RE: 238 Deer St Meeting: August 10, 2021 Work Session

RE: 361 Islington ST Meeting: HDC 08/11/21 Work Session and Public Hearing

RE: 1& 31 Raynes and 203 Maplewood Ave Meeting: HDC 08/11/21 Word session and Public Hearing

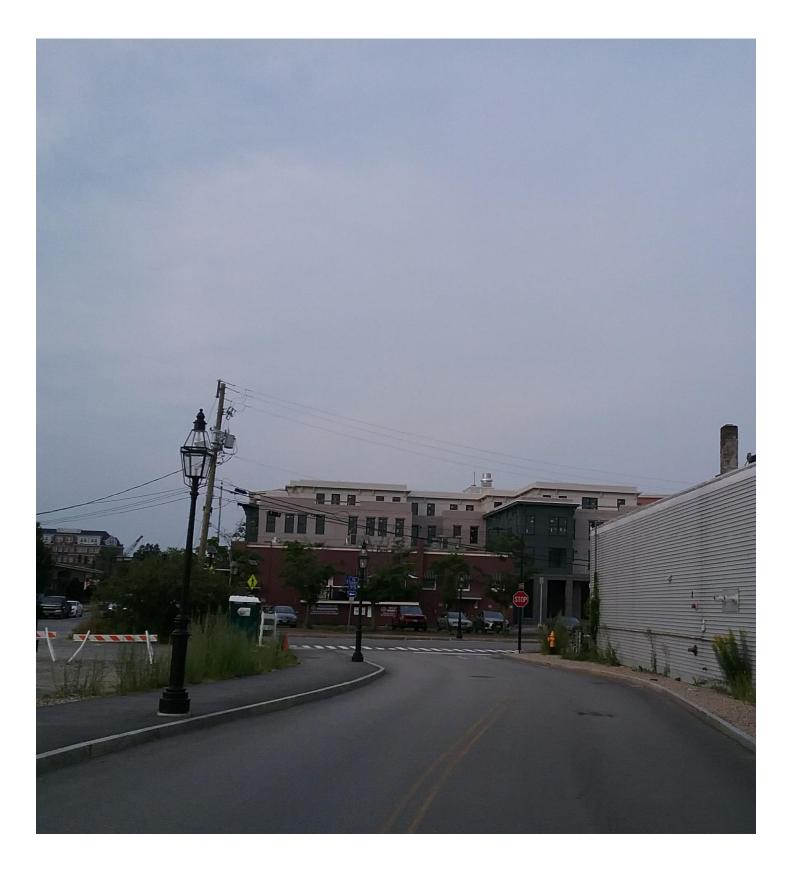
They are showing 4 stories with the top floor recessed by about 13' which will make it less visible and more pleasing to the eye. I was not able to find **HVAC** on the rendering of the penthouse: 4 units, stairs, decks and storage.
